#### **PLN200192 and DA210122/SCHWARTZ MAL**

**SCHWARTZ MAL (PLN200192 and DA210122)**

**RESOLUTION NO. 21 - 264**

**ARCHITECTURAL  
EROSION  
CONTROL /  
CONSTRUCTION  
MGMNT NOTES**

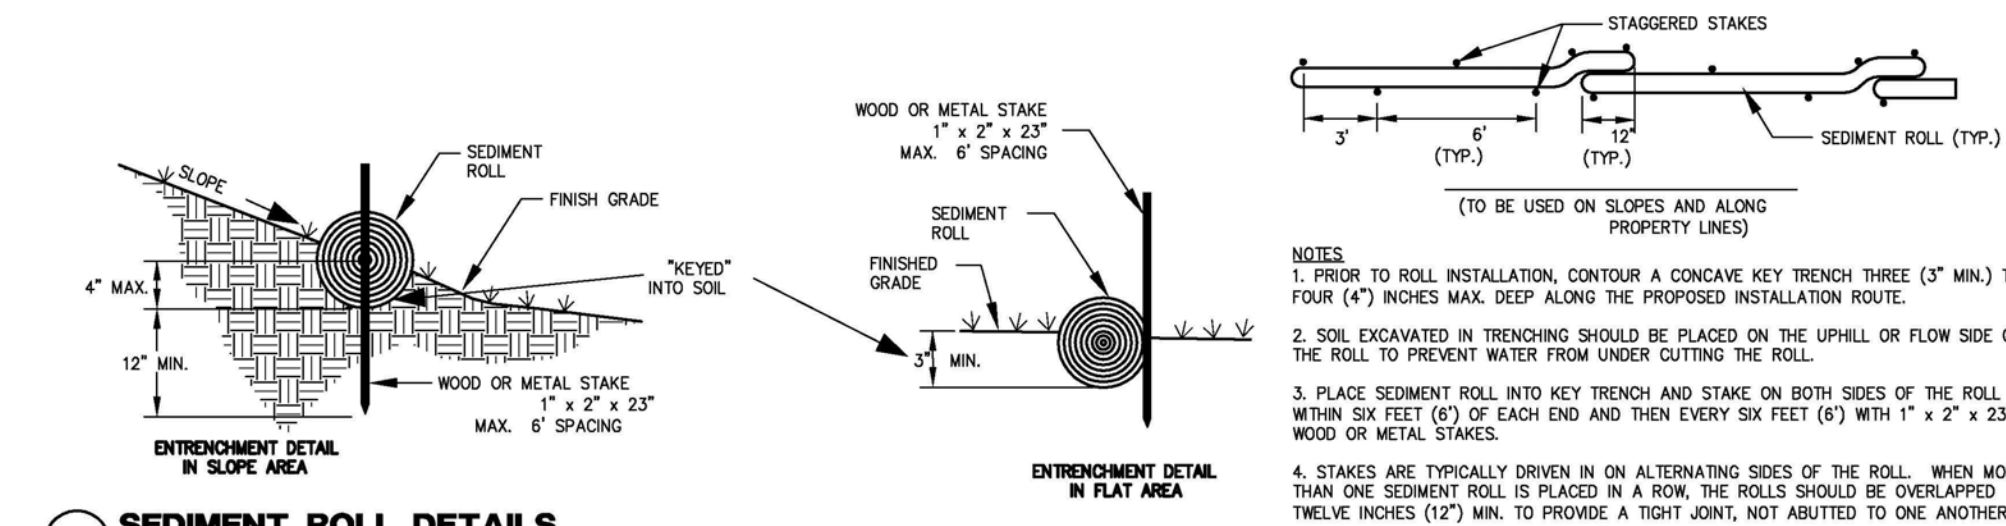
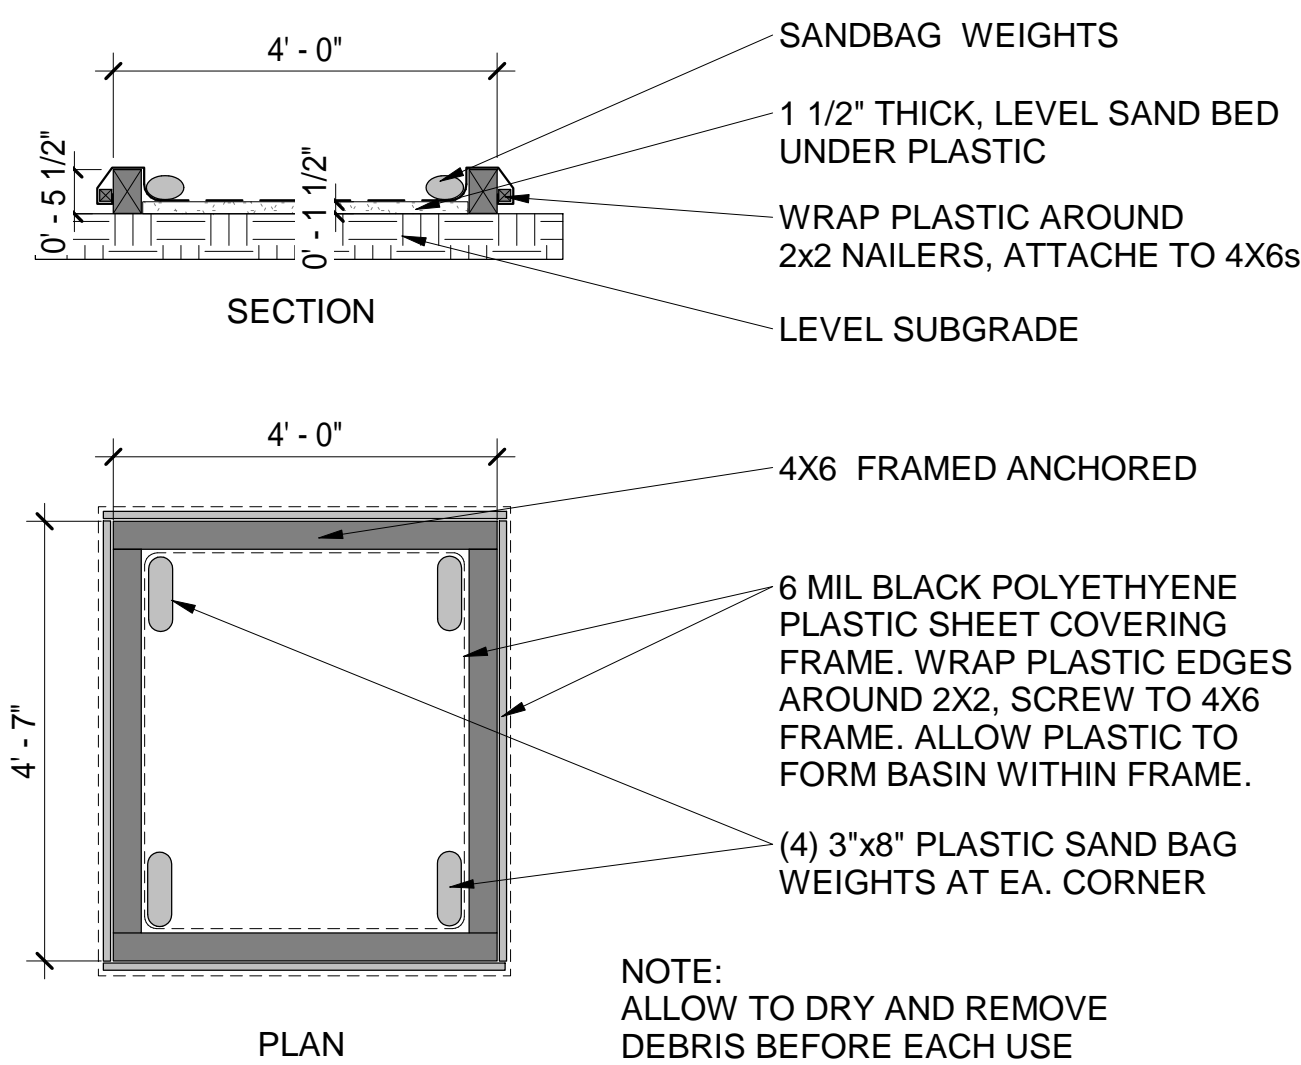
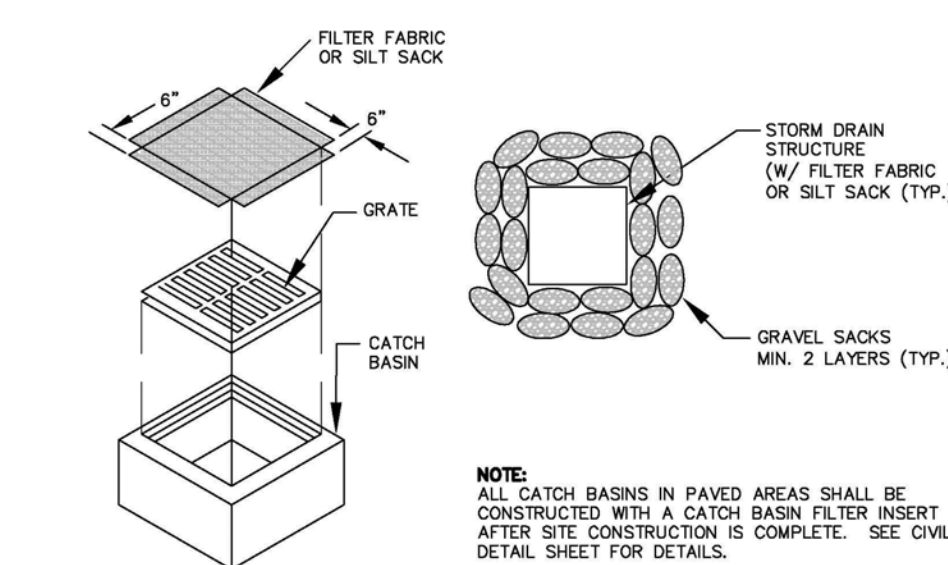
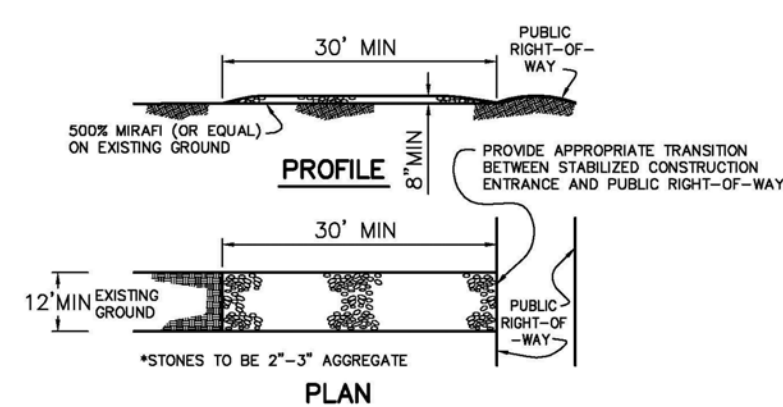
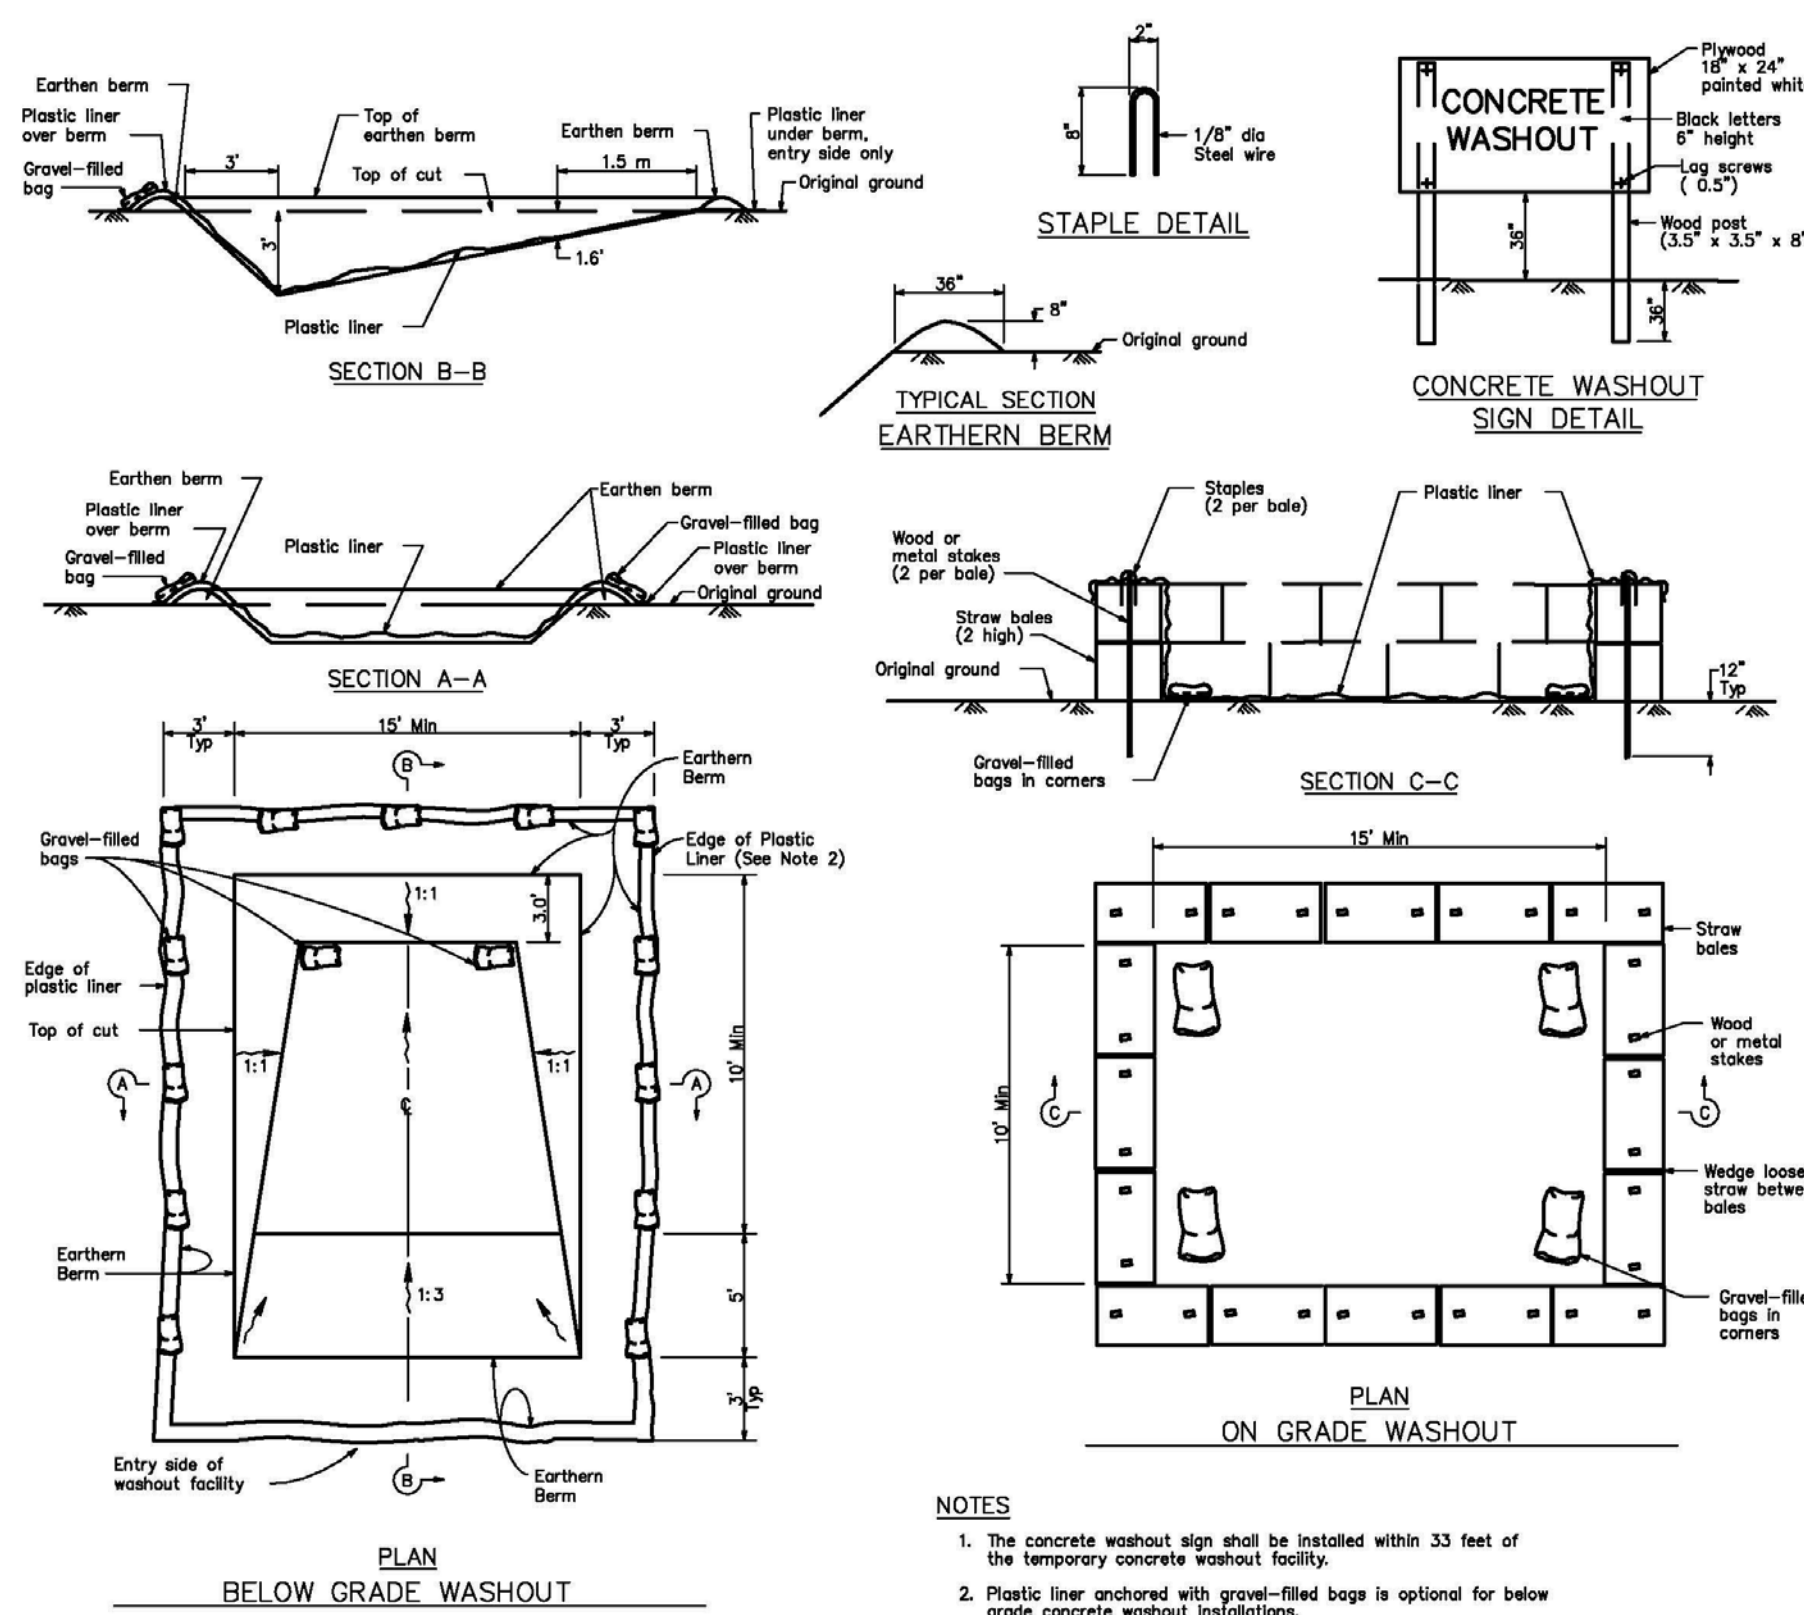
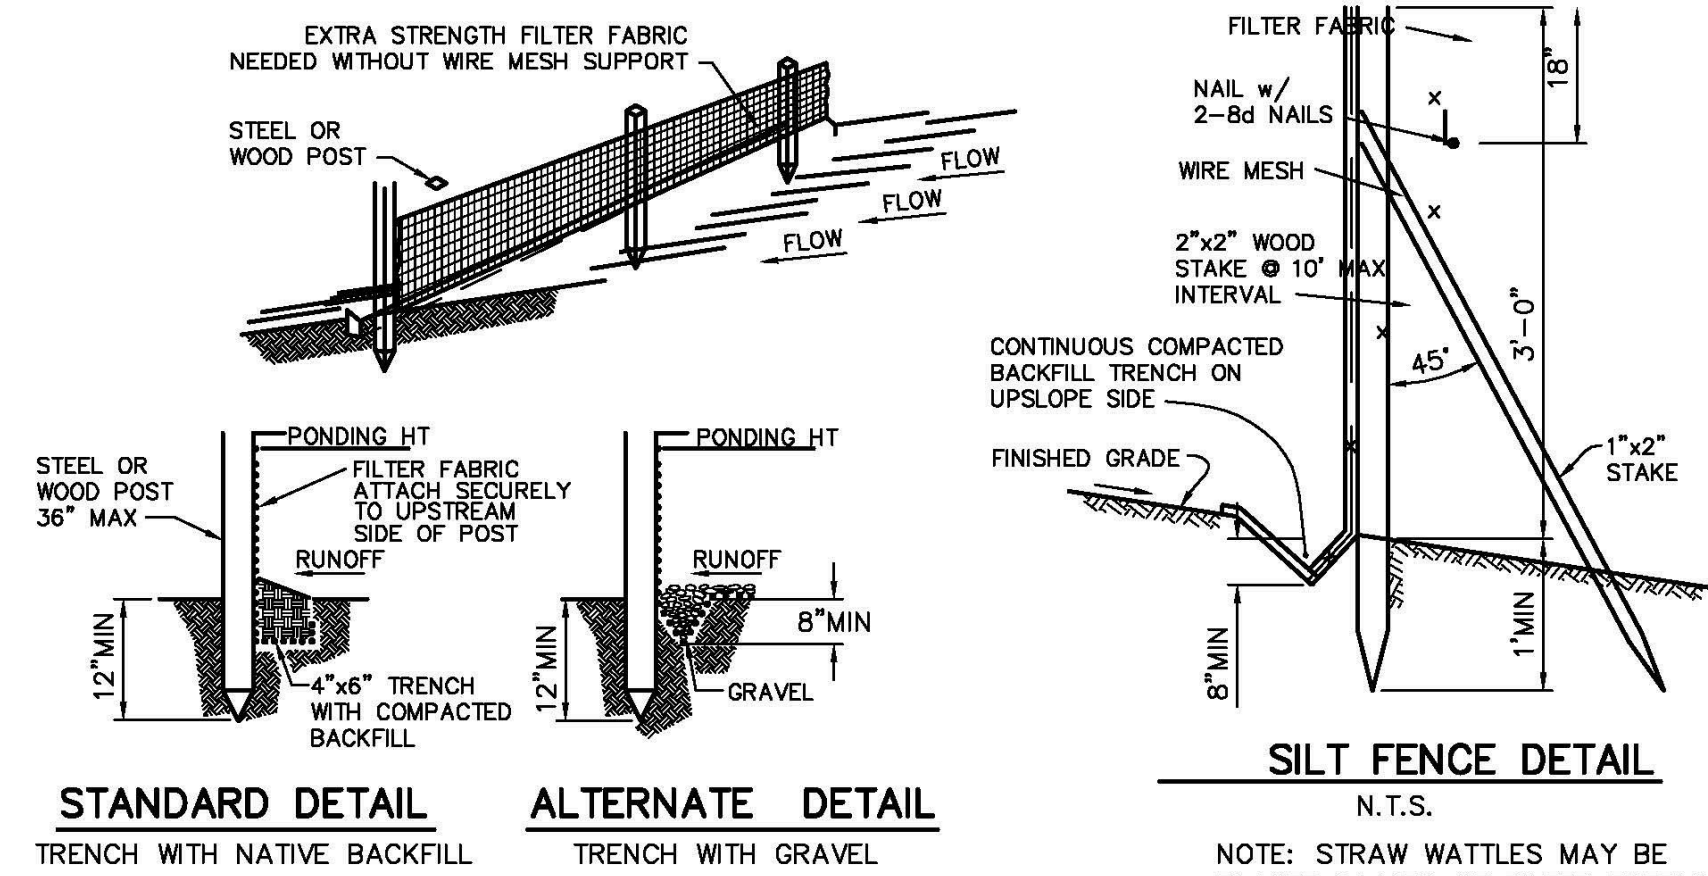
existing concrete patio, while the new 2-car carport is being installed in a paved driveway. Erosion is also controlled through the inclusion of an erosion control / construction management plan, which is shown on sheet G1.6 of the project plans.
